Access Compliance Report

Public Rights-of-Way

(Curb Ramps)

Intersection ID: 2755	Main Street: BELL'S_MILL_DR	Cross Street: RIDGEFIELD_DR	Location: E
ADA ID: CE4A431754CB	Ramp Type: BlendTrans1	Initial Pass/Fail: Pass	Overall Compliance: No
			Severity Score: 14.25

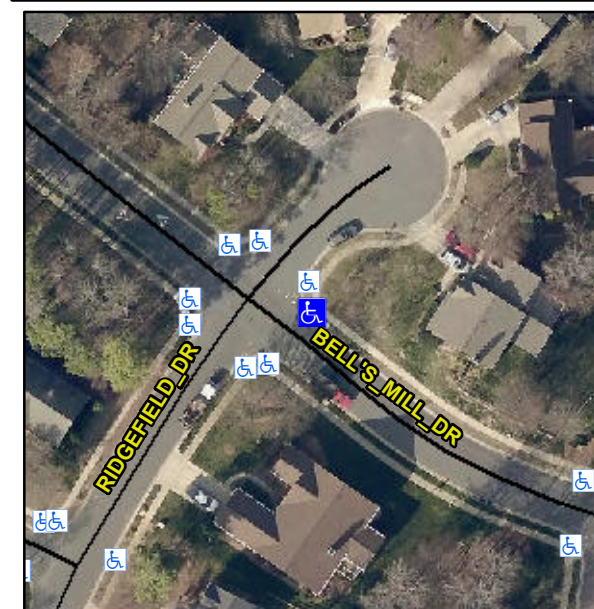
Not Found, R304.2.1, R304.5.3, R305.1.4, R305.2, R302.7.2

Compliance	Description	Data	Compliance	Description	Data
N/A	Ramp Length (in)	50.0	Yes	BlendTrans Slope (%)	3.2
Yes	Ramp Width (in)	48.0	Yes	BlendTrans XSlope (%)	3.4
N/A	Flare Type LT	Sloped	N/A	Flare Type RT	Sloped
N/A	Flare Slope LT (%)	5.4	N/A	Flare Slope RT (%)	3.6
N/A	Flare Traversable LT?	No	N/A	Flare Traversable RT?	No
No	Landing Length (in)	46.0	Yes	DWS Provided?	Yes
No	Landing Width (in)	43.0	Yes	DWS Contrast?	Yes
Yes	Landing Slope (%)	0.6	Yes	DWS Length (in)	24.0
No	Landing X Slope (%)	5.4	No	DWS Full Width?	No
N/A	Landing Curb? (Y/N)	No	No	DWS Offset (in)	13.0
N/A	Shared Landing?	No			
Yes	Gutter Ponding?	No	Yes	Gutter Slope (%)	1.1
No	Gutter Lip Ht (in)	0.3	Yes	Gutter X Slope (%)	0.6
N/A	Painted X Walk1?	No	N/A	Painted X Walk2?	N/A
	X Walk 1 Direction	To SW		X Walk 2 Direction	N/A
	X Walk 1 Width (in)	N/A		X Walk 2 Width (in)	N/A
	X Walk 1 Slope (%)	2.3		X Walk 2 Slope (%)	N/A
	X Walk 1 X Slope (%)	4.2		X Walk 2 X Slope (%)	N/A

N/A	Ramp inside XWalk1?	N/A	N/A	Ramp inside XWalk2?	N/A
	Road Slope (%)	4.2		Clear Space?	Yes
	Road X Slope (%)	2.3	N/A	Clear Space to XWalk (in)	N/A
Yes	Any Obstructions?	No	Yes	Storm Grate/Utility Hazard?	No
	Obstruction Type			Storm Grate/Utility Type	
		N/A			N/A
			Yes	Surface Condition? (G/P)	Good
			No	Curb Slope (%)	8.5

Remove & Replace Curb Ramp With Two New Directional Ramps or Equivalent.
